Response to Comments

**Draft Cleanup Action Plan, Agreed Order,
and State Environmental Policy Act –
Determination of Non-Significance**

**Boeing Isaacson Thompson Cleanup Site
Tukwila, WA**

April 2025

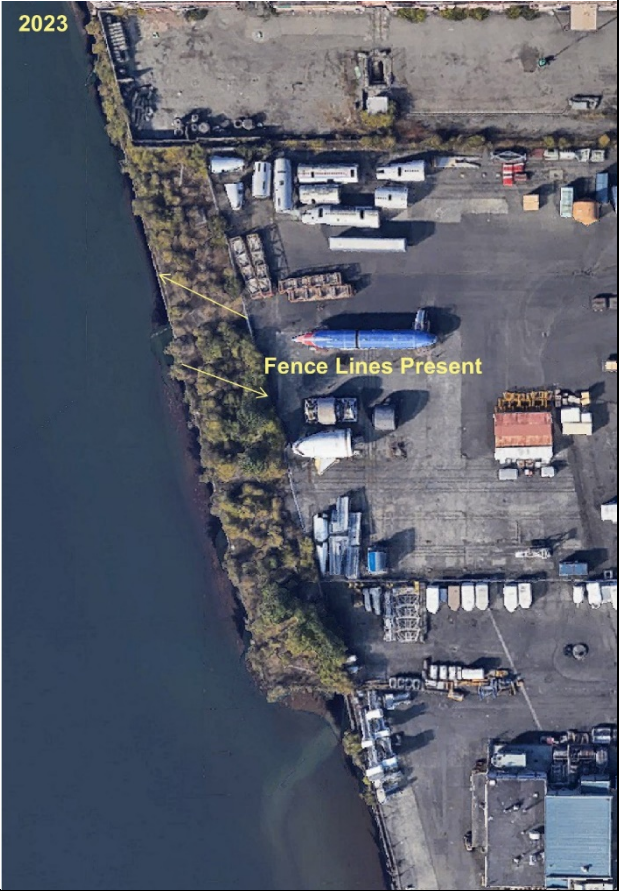
Please see below for comments from the Port of Seattle (“Port”) on the Boeing Isaacson-Thompson Site (“Site”) Agreed Order (“AO”) and Cleanup Action Plan (“CAP”) draft documents out for public comment. First, we provide general comments regarding the Site and the draft documents. Following that is a table providing specific comments, identified by sections within the documents. Above all, the Port emphasizes that the Port Sliver bulkhead or physical landmass need not be reconstructed following remediation.

A. The Port Sliver Should Not be Reconstructed

As previously explained to Ecology during the public comment period on the Remedial Investigation/Feasibility Study (RI/FS), the Port did not construct the Port Sliver, nor has it ever conducted operations on, or contributed contamination to, the property. And insofar as the Port Sliver will be excavated as part of Site remediation, from the Port’s perspective, the property should not be reconstructed following remediation. The Sliver falls within the 500-foot right-of-way that should be part of the Lower Duwamish Waterway (LDW). If Boeing or another party wishes to utilize the area for their own purposes in a way that does not interfere with navigation or other public rights, the Port cannot and would not oppose such efforts, but reconstruction of the Sliver is not necessary for protection of human health or the environment, or for navigational purposes. The Port has previously communicated this position to Boeing and Ecology.

The dCAP proposes that the Port Sliver will be excavated to a depth of approximately 18 feet below ground surface. The purpose of the excavation is to remove contaminants of concern in soil until concentrations are below applicable cleanup levels. Clean fill will be placed to fill the excavated area to an elevation above the high-water line to protect the exposed areas of the shoreline from erosion and to support the permeable reactive barrier.

Ecology has taken note of the Port’s comment regarding the potential for using less fill to reduce the footprint of the Port Sliver. The excavation limits and backfill design will be refined during the remedial design stage of the project, which will be informed by the Pre Remedial Design Investigation (PRDI) and presented in the Engineering Design Report (EDR).
